Southern Nuclear
Operating Company, Inc.
42 Inverness Center Parkway
Birmingham, Alabama 35242

December 9, 2016

Southern Nuclear Operating Company
Vogtle Electric Generating Plant Units 3 and 4
Request for License Amendment and Exemption:
Ventilation System Changes (LAR-16-030)

(LAR-16-030)

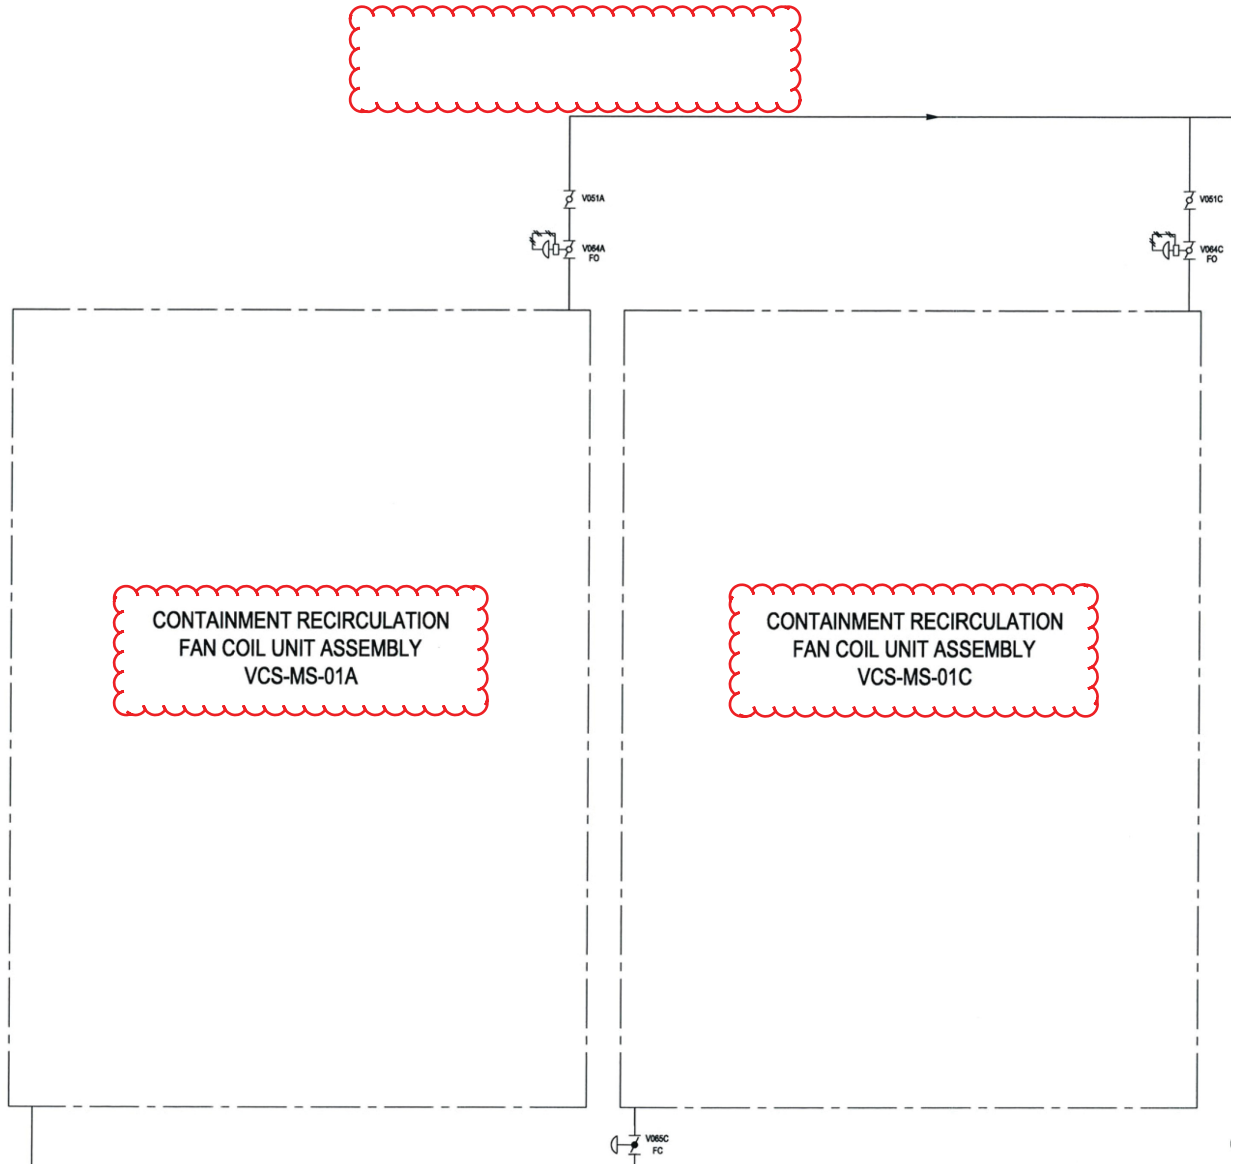
Revise Tier 1 information, as shown below:

3. **UFSAR Section 9.2, "Water Systems," Figure 9.2.7-1 (Sheet 3 of 4), "Simplified Central Chilled Water System Piping and Instrumentation Diagram (REF) VWS 003":**

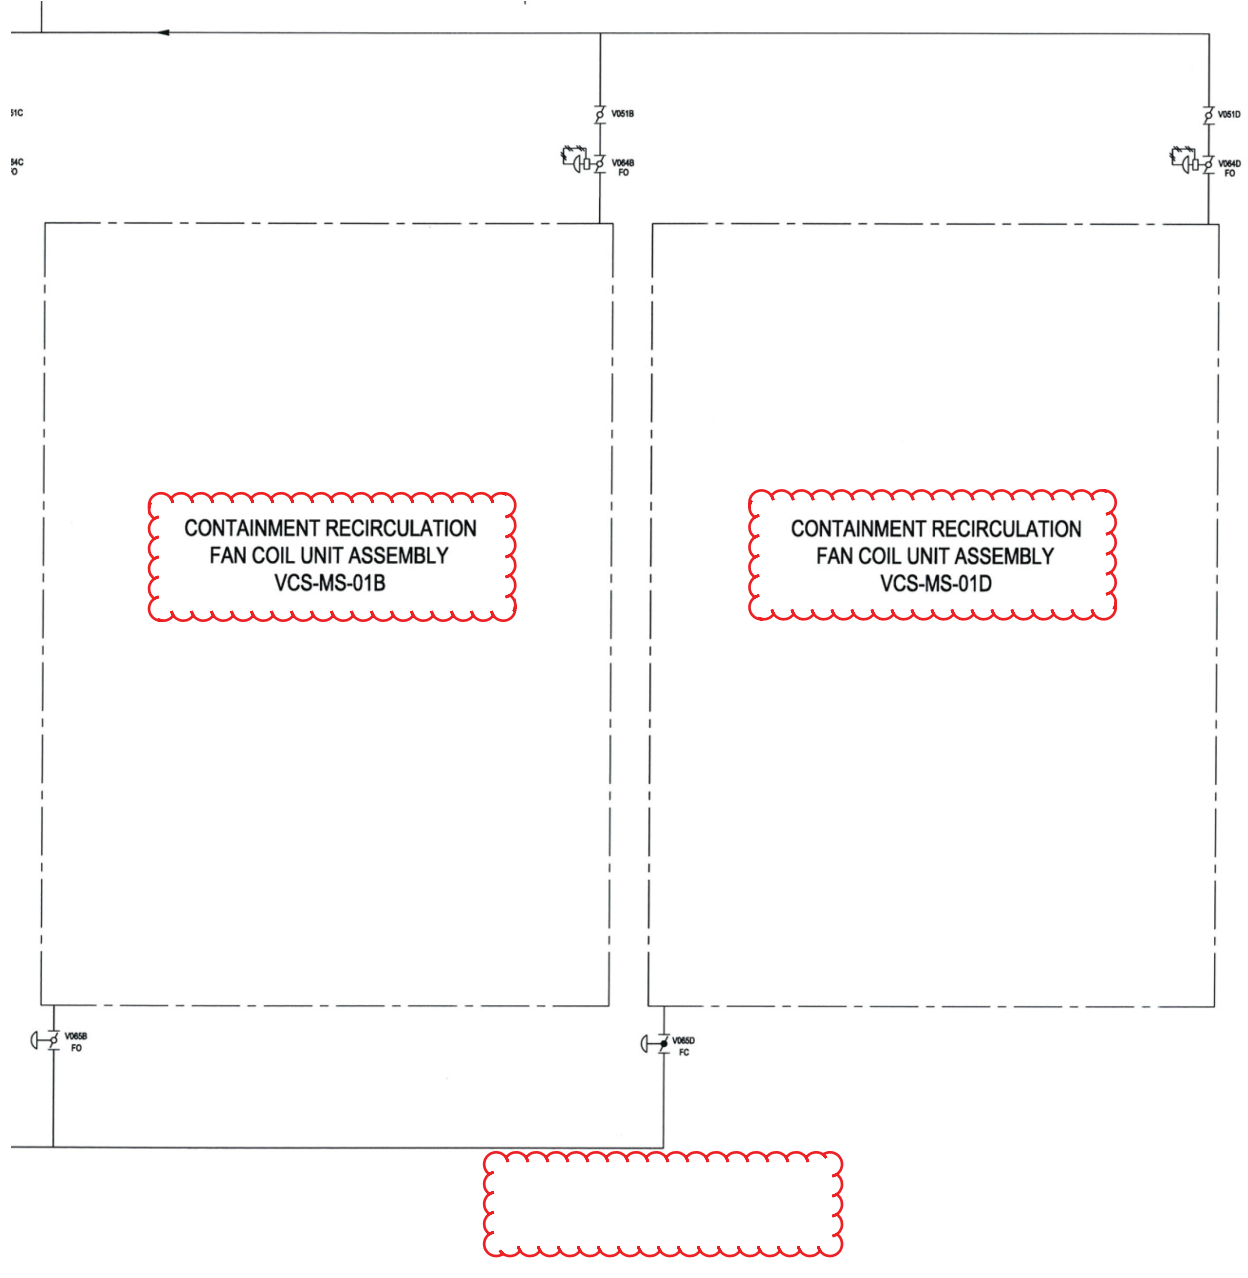
Revise Tier 2 information to add new containment recirculation fan coil unit assembly, VCS-MS-01C, to the units served by the central chilled water system (VWS) and alternately by the hot water heating system (VYS), as depicted below in the excerpt from the left side of the figure:

Revise Tier 2 information to add new containment recirculation fan coil unit assembly, VCS-MS-01D, to the units served by the VWS and alternately VYS, as depicted below in the excerpt from the right side of the figure:

8. **UFSAR Section 9.4, Figure 9.4.6-1, "Simplified Containment Recirculation Cooling System Piping and Instrumentation Diagram (REF) VCS 001":**

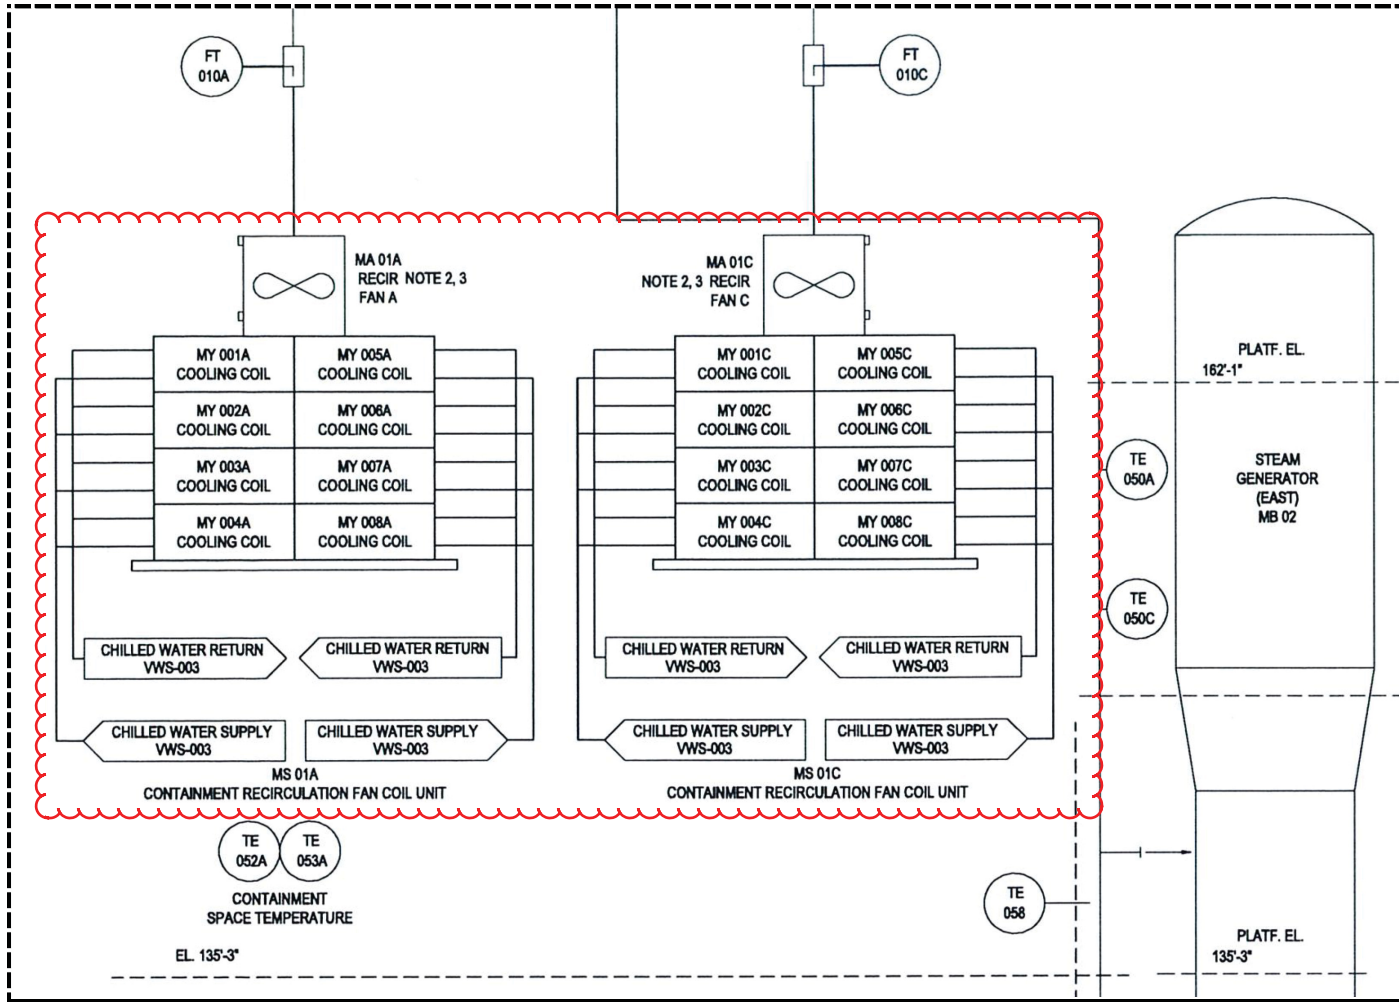
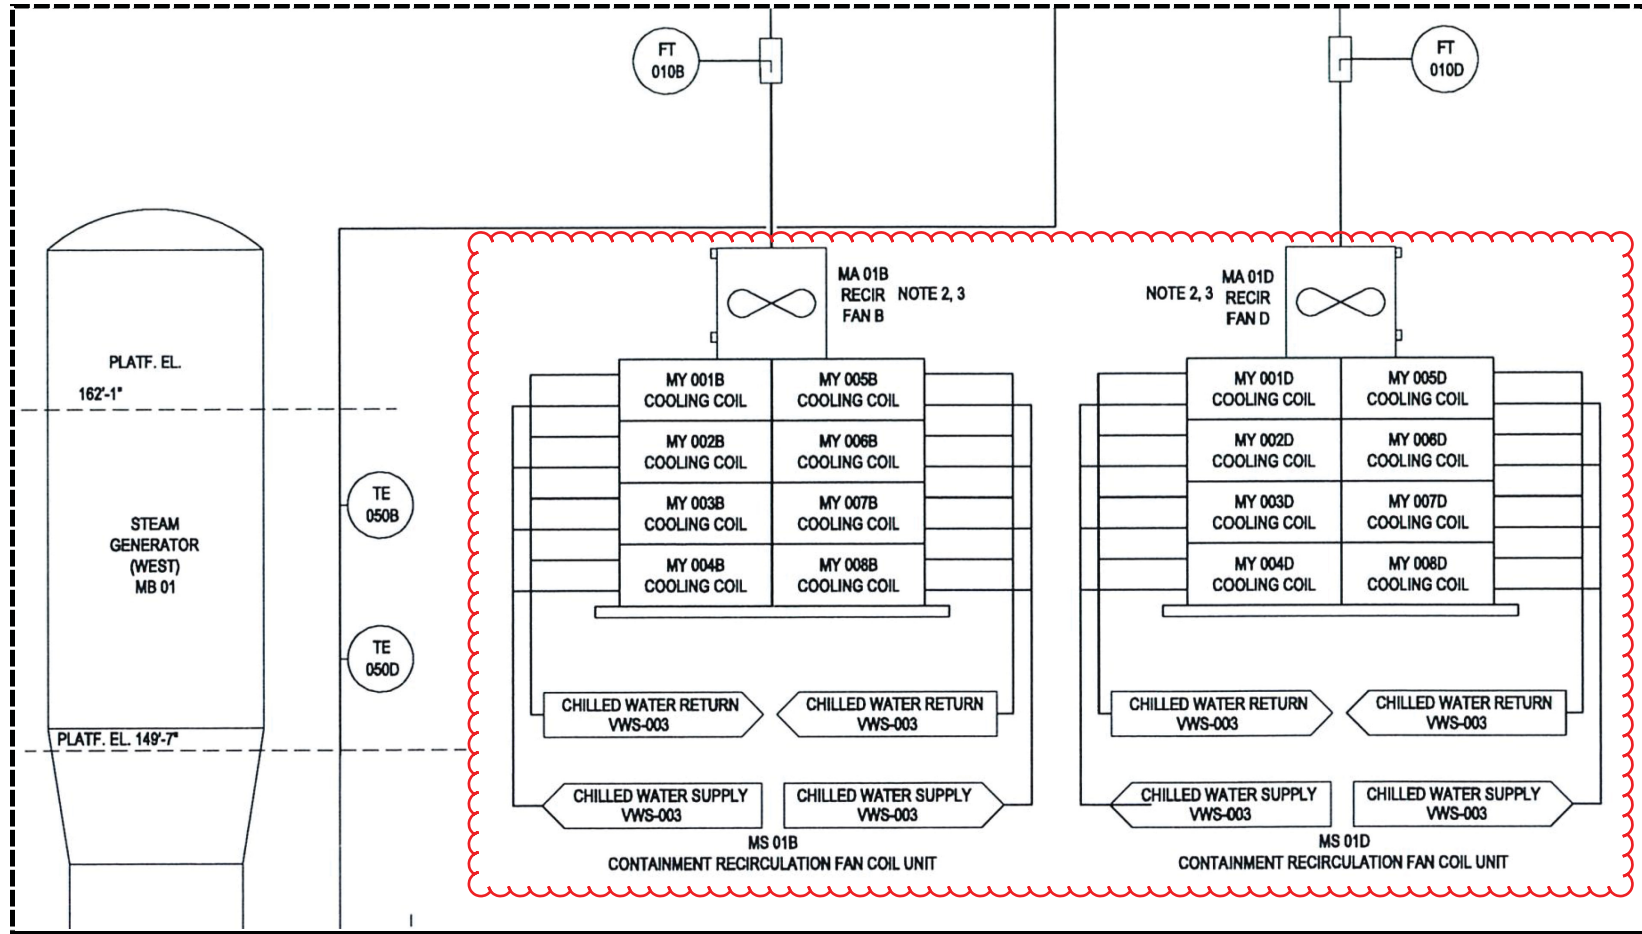
Revise Tier 2 information to change the number and configuration of the containment recirculation fan coil unit assemblies, as depicted below in the excerpt from the left side of the figure:

Revise Tier 2 information to change the number and configuration of the containment recirculation fan coil unit assemblies, as depicted below in the excerpt from the right side of the figure:
